## HISTORIC AND DESIGN REVIEW COMMISSION

December 06, 2017

**HDRC CASE NO:** 2017-618  
**ADDRESS:** 930 LAMAR ST  
**LEGAL DESCRIPTION:** NCB 1655 BLK C LOT 22  
**ZONING:** R-5  
**CITY COUNCIL DIST.:** 2  
**DISTRICT:** Dignowity Hill Historic District  
**APPLICANT:** Poma Properties  
**OWNER:** Poma Properties  
**TYPE OF WORK:** rear addition, rear deck, window replacement, fenestration changes, fencing  
**APPLICATION RECEIVED:** November 7, 2017  
**60-DAY REVIEW:** January 6, 2018  
**REQUEST:**

Proposed Elevations.

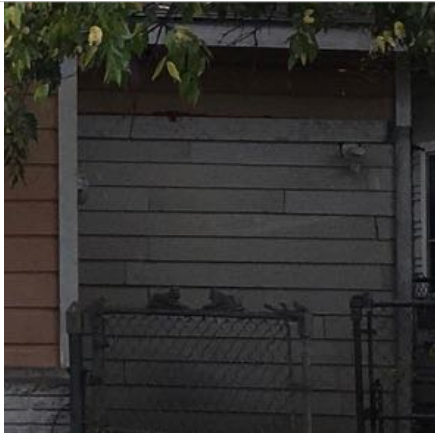
- b. REAR ADDITION – The applicant has proposed to construct a 223 square feet addition in the rear of the structure. The proposed addition features a matching siding material and roof form as the existing structure. The proposed addition also features a new centered window opening, which at this time, the applicant has proposed the installation of 36 by 60 inch vinyl windows. Per the Guidelines for Addition 3.1.A and B, staff finds the addition generally appropriate. The applicant can work with staff to finalize the window detail.

- h. BAY WINDOW – The applicant is requesting to modify the bay window by removing the wrought iron columns and brick planters and replacing the existing shed roof with a tapered roof. A site visit conducted by staff on November 27, 2017 verified that the bay columns do not match the porch columns and the planter bricks do not match the brick veneer of the primary structure. Staff finds that the bay columns and planters are not original to the historic structure and that the proposal to remove it with modifications to the bay roof appropriate.

- j. NEW WINDOWS – The applicant is requesting to install two (2) new window openings to feature 36 by 60 inch vinyl double-hung windows. One window will be installed on the front façade at the end of the driveway and the another window will be installed on the rear elevation of the proposed addition. Staff finds there is precedent for window openings at these locations, and their installations will not negatively impact the façade or integrity of the property. However, staff does not find the proposed window type (double-hung vinyl) appropriate given the context from finding i.

- i. Staff recommends approval of the rear addition.
- ii. Staff recommends approval of the rear deck with the stipulation that a detail drawing be submitted to staff.
- iii. Staff recommends approval of the rear privacy fence.
- iv. Staff recommends approval the double-doors with the stipulation that the removed window be reused at another location on the property.

- v. Staff does not recommend approval to replace the porch columns.
- vi. Staff does not recommend approval to install a front porch deck and railing.
- vii. Staff recommends approval of bay window modifications.
- viii. Staff does not recommend approval at this time. Staff recommends that the applicant work with staff to find a suitable window that is eligible for administrative approval.
- ix. Staff recommends approval of new window openings with the stipulation that the applicant works with staff to find windows suitable for the structure and consistent with the Guidelines.

Window Detail Cont.

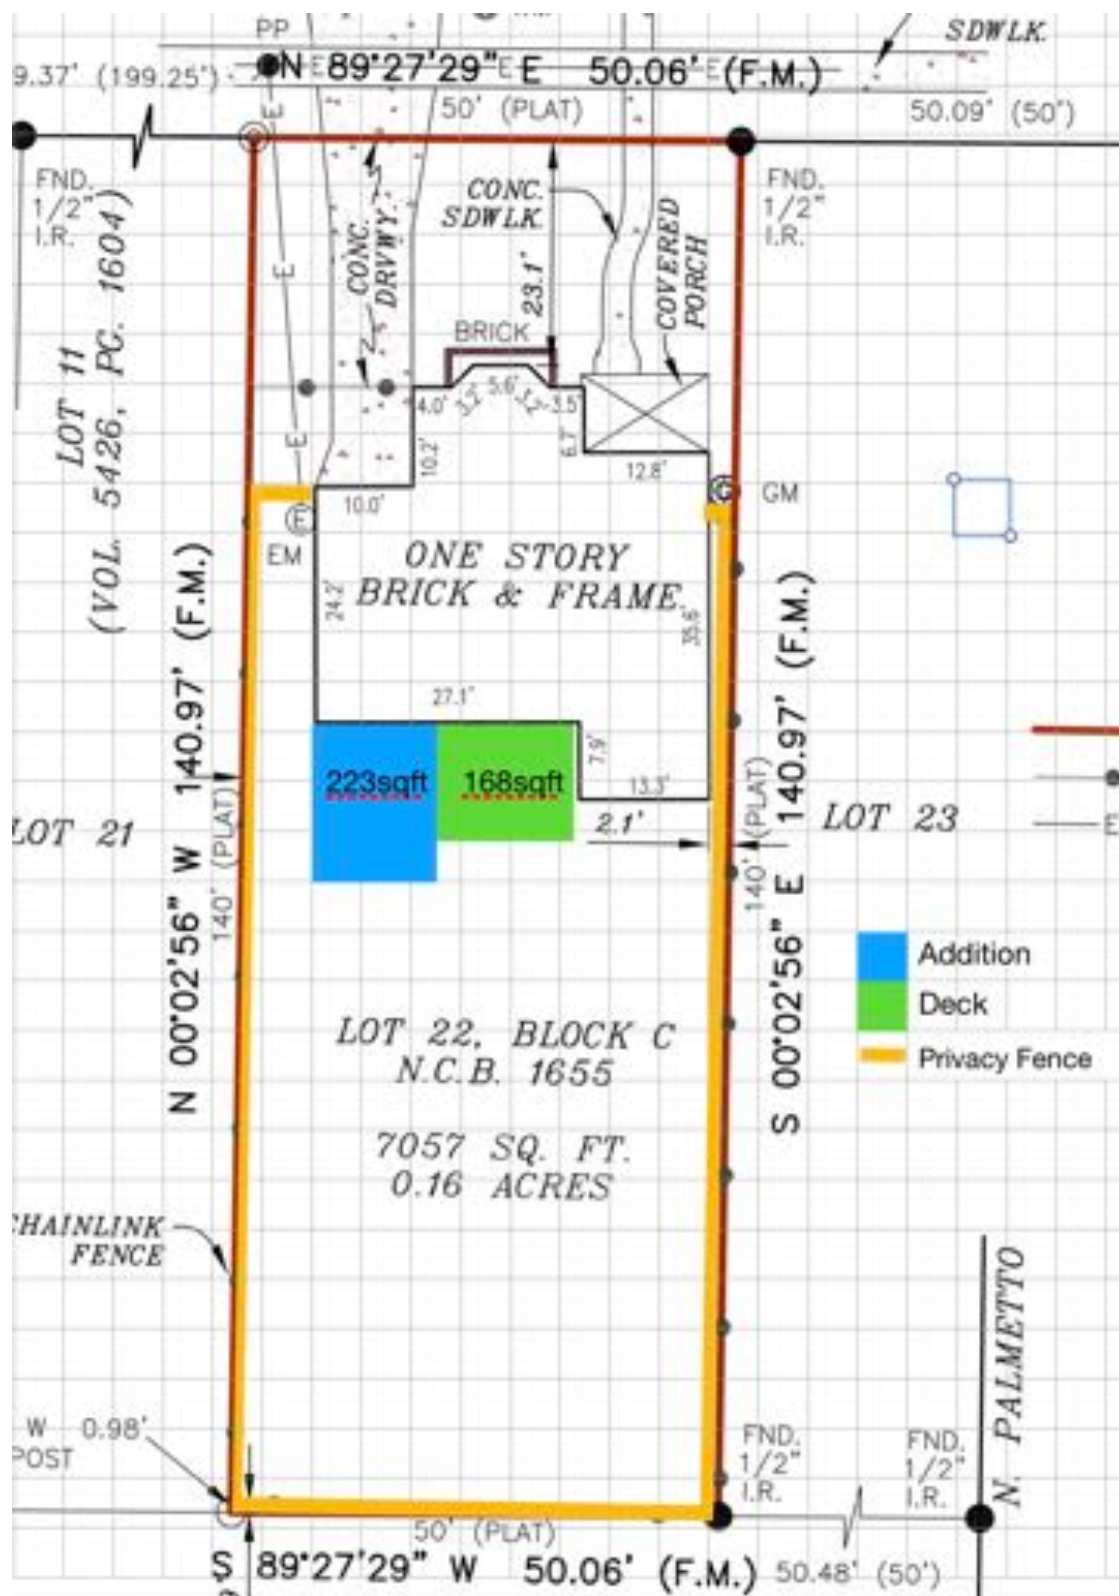
- e. REMOVE WINDOW/INSTALL DOOR– The applicant is requesting to remove an original casement window featuring 6 divided lights in the rear of the property to install a new double-door entry onto the proposed rear deck. The proposed doorway will feature 15-light external grill white steel double-doors. While the Guidelines for the Architectural Features 6.A.i. notes that existing window and door openings should be preserved, staff finds the proposal to replace a window opening with a door opening in the rear appropriate given that the changes will not be visibly from the public right-of-way. The applicant should salvage the removed window to reuse in the other request for window installation and replacement.

- i. WINDOW REPLACEMENT – The applicant is requesting to replacement two (2) non-historic aluminum double-hung windows with 36 by 60 inch vinyl double-hung windows. The Guidelines for Architectural Features 6.B.vii. notes that non-historic incompatible windows with windows that are typical of the architectural style of the building. The remaining 12 of the total 14 windows are fixed or casement windows with divided lights. Staff does not find the vinyl double hung windows to be an appropriate replacement for the two non-historic windows. The applicant can work with staff to find appropriate replacement windows with details and materials consistent with the Guidelines.

## Site Map

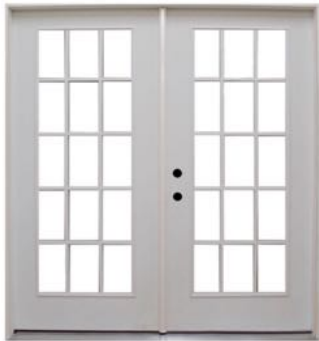
construction. No construction documents have been submitted at this time. Based on the elevation drawing and site plan, staff finds the proposed deck appropriate as it will not be visible from the public right-of-way.

- d. FENCE – The applicant has proposed to install a wood privacy fence of 6 feet in height set back from the front place of the structure. Staff finds the fence consistent with the Guidelines for New Fences and Walls B. and C.
